CERTIFICATE OF APPROPRIATENESS PLACARD

817 HILLSBOROUGH STREET

BOYLAN APARTMENTS

Written Description of Proposed Work

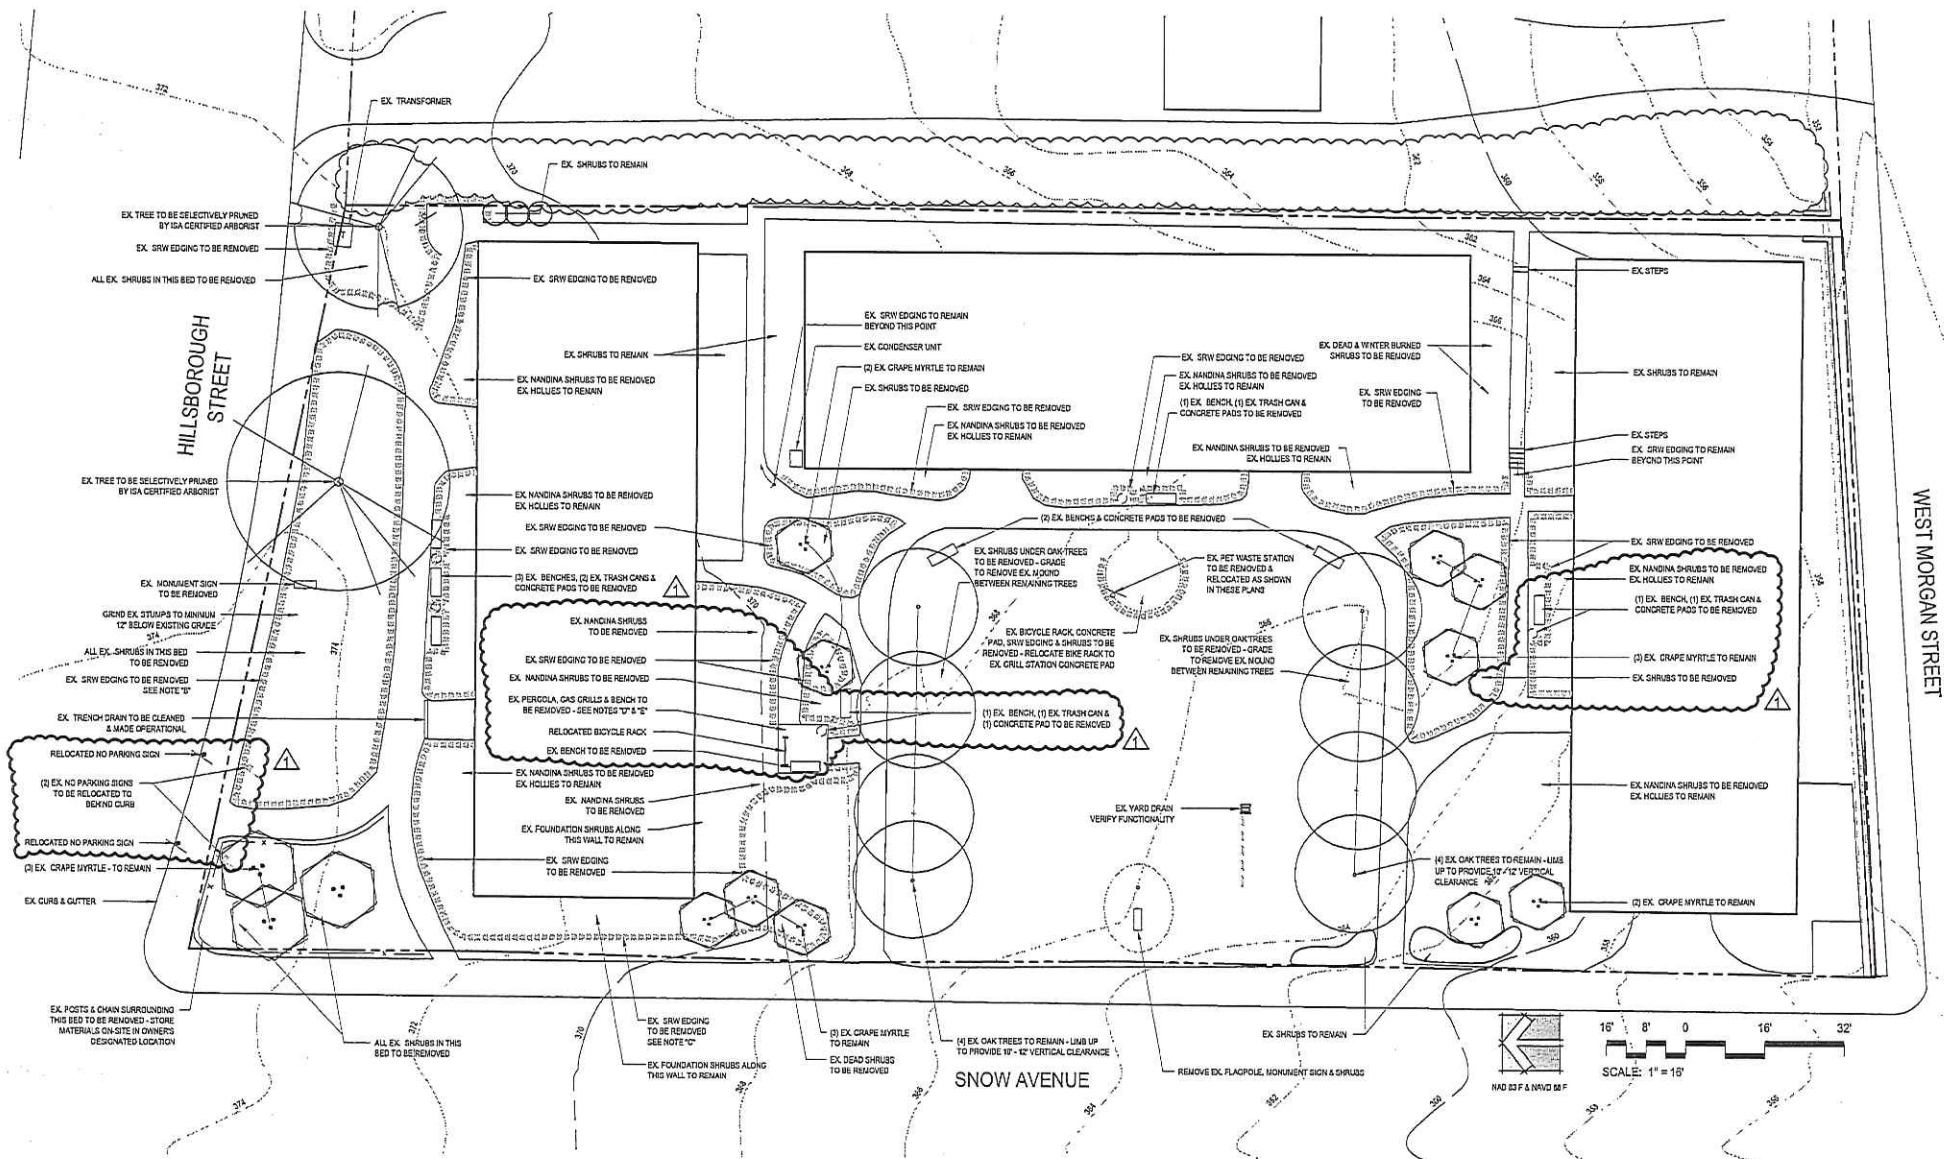
- **On the site plan**, please indicate where the relocated "No Parking" signs are proposed to be placed.
- In terms of the third item under "Courtyard/Snow Avenue Side" please indicate the number of benches and trash receptacles that are to be removed. Also, please provide a picture of those elements.
- Additionally, for the fourth item under "Courtyard/Snow Avenue Side" please provide a picture of that area. You reference Photo 4 but that is for the "Front Yard/Hillsborough Side". Same comment for the sixth item under "Courtyard/Snow Avenue Side".
- Provide a picture of the bicycle rack to be relocated and indicate **on the site plan** where in the adjacency of the pergola it will be relocated to.
- For the tenth item under "Courtyard/Snow Avenue Side" please indicate how many pet waste stations are to be removed. Please provide a reference photo.

We have revised the plan, description and photographs to address your comments. The corresponding files are attached for your review. Let me know if you need hard copies for your files.

4. Remove the ex. posts & chain surrounding the bed at the northwest corner of the property (Hillsborough St. at Snow Ave.) (Photo 5)
5. Relocate two (2) ex. "No Parking" signs to behind the curb. This location matches other signs in the vicinity. (Photos 4 & 5)

RELOCATED NO PARKING SIGN

(2) EX. NO PARKING SIGNS TO BE RELOCATED TO BEHIND CURB

RELOCATED NO PARKING SIGN
